STRATFORD HURRICANE BARRIER

SUBJECT: Stamford Hurricane Barrier, Stamford, Connecticut
Design Memorandum No. 3 - General

SUBJECT: Stamford Hurricane Barrier, Stamford, Connecticut
Design Memorandum No. 3 - General

2. Design Memorandum No. 3 and the revised pages referenced in paragraph 1 above, are approved subject to the following comments:

PANEL WALL - TYPICAL DETAILS

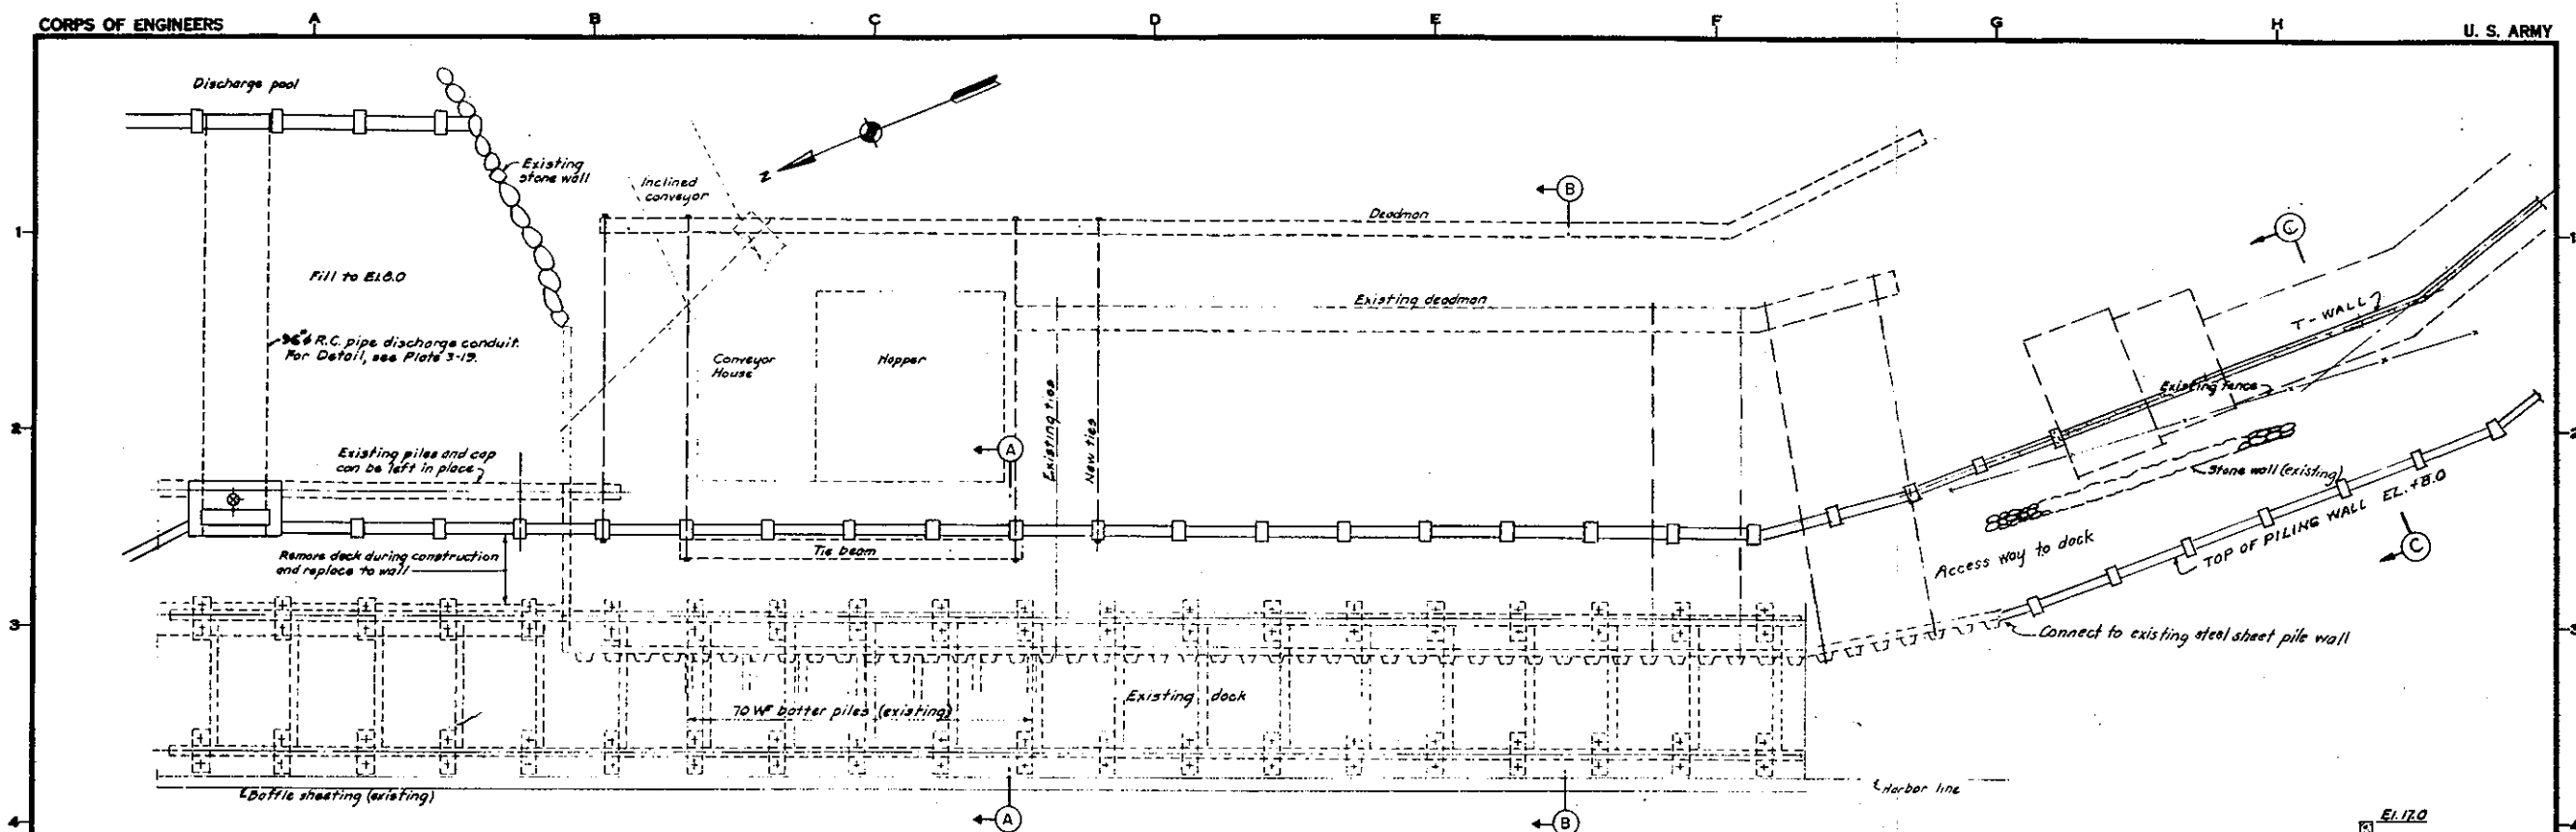
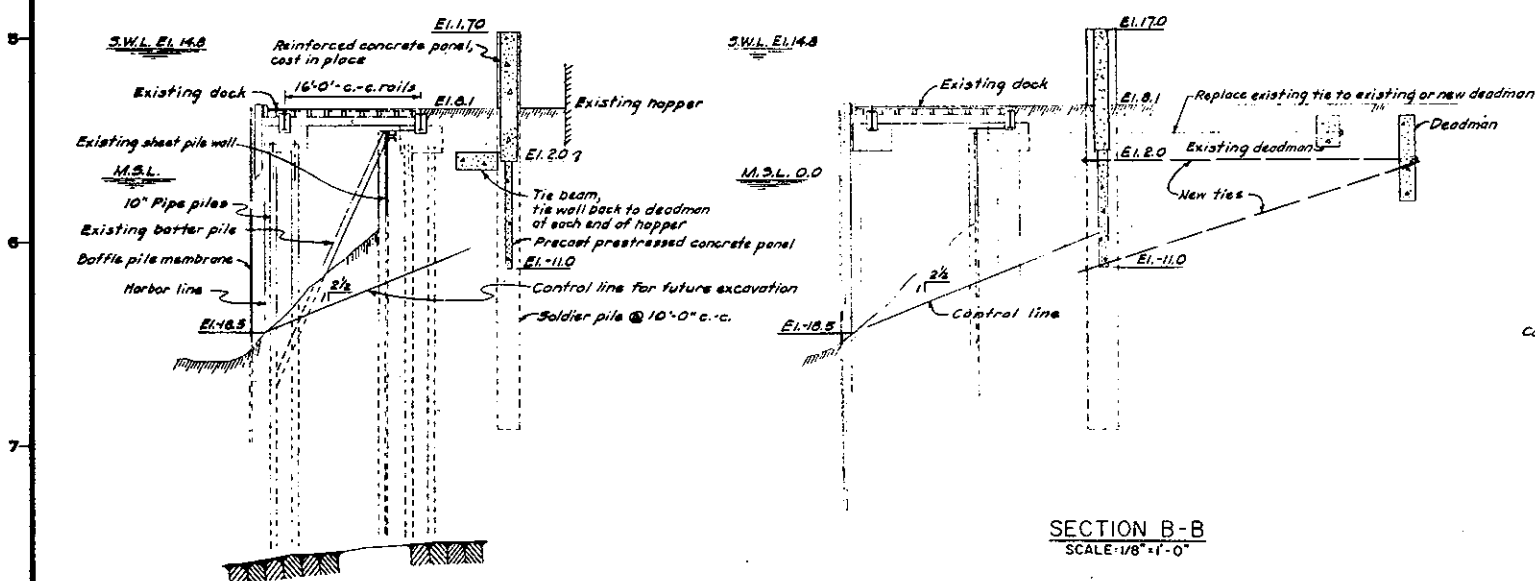
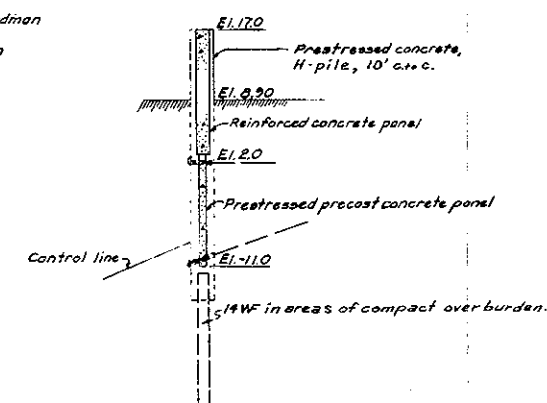
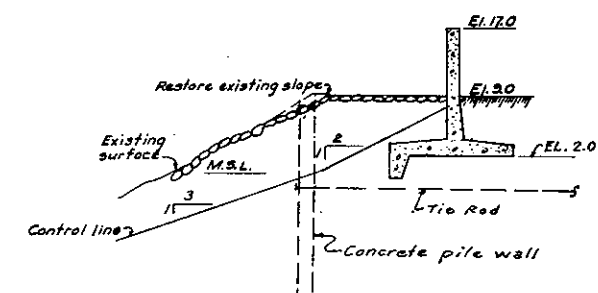
b. Plates 3-7 and 3-8. Consideration should be given to protecting the panel wall with a wood bumper system anchored to the concrete piles in locations where ships are expected to dock.
